## The Landings, Ford Airfield

## Phase RM4 (South)

## Transport Technical Note

IRM STAGE 1 ROAD SAFETY AUDIT DESIGNER'S  
RESPONSE

Plan attached showing the locations of the problems identified as part of this audit (location numbers refer to paragraph numbers in the report).

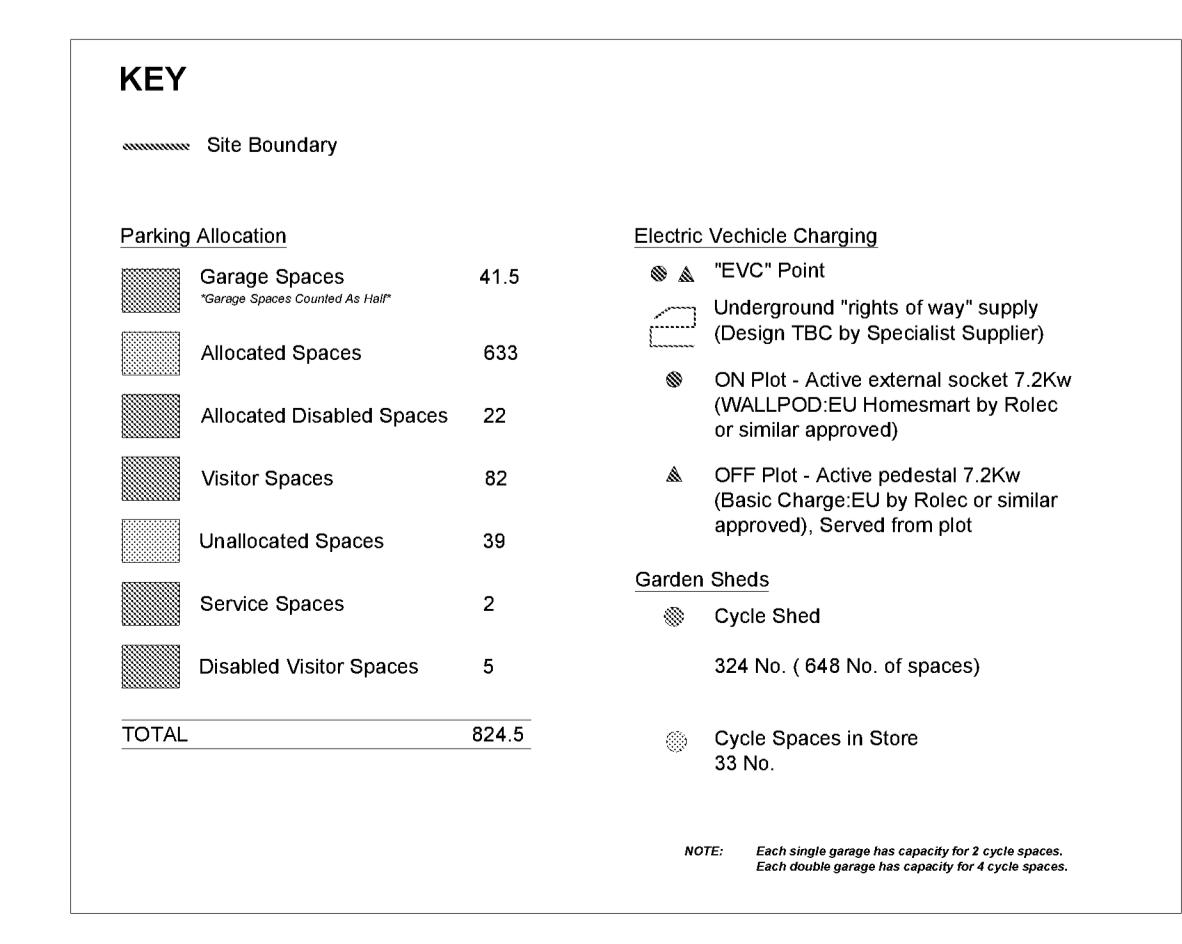
**Summary:** Insufficient construction detail on raised tables could lead to loss of control collisions.

It is recommended that PPTV details should be checked to ensure they provide adequate grip resistance for the speed of road.

There is a chicane/traffic calming feature proposed with no details provided. Auditors are unable to comment further on this without further details on the traffic calming feature, which could compromise road safety.

There is a chicane/traffic calming feature proposed with no details provided. Auditors are unable to comment further on this without further details on the traffic calming feature, which could compromise road safety.

There is a chicane/traffic calming feature proposed with no details provided. Auditors are unable to comment further on this without further details on the traffic calming feature, which could compromise road safety.

No forward visibility splays have been provided; planting is proposed within the forward visibility splay. There is concern that landscaping exceeding 600mm in height within the visibility splays could adversely affect visibility, which could lead to side impact collisions or rear end shunts.

Visibility splays at the accesses have been provided; however, planting is proposed within visibility splays. There is concern that landscaping exceeding 600mm in height within the visibility splays could adversely affect visibility, which could lead to side impact collisions or rear end shunts.

It is recommended that a plan showing the light distribution should be provided for assessment at Stage 2 Safety Audit.

3.1.4 – Proposed raised tables  Insufficient construction details could lead to vehicle to pedestrian / cyclist collisions.  No construction details were provided for assessment; however, these did not include details of the Polished Paver Test Value (PPTV) of the concrete block paving for the raised tables. Inappropriate carriageway construction with low PPTV values could lead to vehicle to pedestrian / cyclist collisions.	It is recommended that PPTV details should be checked to ensure they provide adequate grip resistance for the speed of road.	PPTV will be designed to provide adequate grip resistance for speed of road in accordance with West Sussex Highway Design Specification and presented for stage 2 audit.

3.1.10 - Proposed chicane/traffic calming feature  Ineffective traffic calming could lead sudden braking and rear end shunt collisions or head on collisions.  There is a chicane/traffic calming feature proposed with no details provided. Auditors are unable to comment further on this without further details on the traffic calming feature, which could compromise road safety.	It is recommended that details of the traffic calming feature should be supplied for assessment.	Details of traffic calming feature will be provided at Safety Audit Stage 2

3.1.11 - Proposed chicane/traffic calming feature  Ineffective traffic calming could lead sudden braking and rear end shunt collisions or head on collisions.  There is a chicane/traffic calming feature proposed with no details provided. Auditors are unable to comment further on this without further details on the traffic calming feature, which could compromise road safety.	It is recommended that details of the traffic calming feature should be supplied for assessment.	Details of traffic calming feature will be provided at Safety Audit Stage 2

<p>3.1.12 - Proposed chicane/traffic calming feature</p> <p>Ineffective traffic calming could lead sudden braking and rear end shunt collisions or head on collisions.</p> <p>There is a chicane/traffic calming feature proposed with no details provided. Auditors are unable to comment further on this without further details on the traffic calming feature, which could compromise road safety.</p>	<p>It is recommended that details of the traffic calming feature should be supplied for assessment.</p>	<p>Details of traffic calming feature will be provided at Safety Audit Stage 2</p>		
<p>3.2.1 - Bend on the Spine Road</p> <p>Lack of visibility could lead to side impact collisions or rear end shunts.</p> <p>No forward visibility splays have been provided; planting is proposed within the forward visibility splay. There is concern that landscaping exceeding 600mm in height within the visibility splays could adversely affect visibility, which could lead to side impact collisions or rear end shunts.</p>	<p>It is recommended that the associated landscaping within the visibility splays should not exceed 600mm in height and that a regular maintenance programme should be employed.</p>	<p>Landscaping within visibility splay designed to not exceed 600mm, with regular maintenance programme instigated</p>

3.5.2 – The scheme  Insufficient street lighting could lead to vehicle to pedestrian / cyclist collisions or side impact collisions.  No details of street lighting have been provided for assessment. Insufficient street lighting could compromise road safety and may reduce the visibility of pedestrians and cyclists during the hours of darkness, particularly at junctions. This could lead to vehicle to pedestrian / cyclist collisions or side impact collisions.	It is recommended that a plan showing the light distribution should be provided for assessment at Stage 2 Safety Audit.	Agreed - Light distribution will be provided at Safety Audit Stage 2
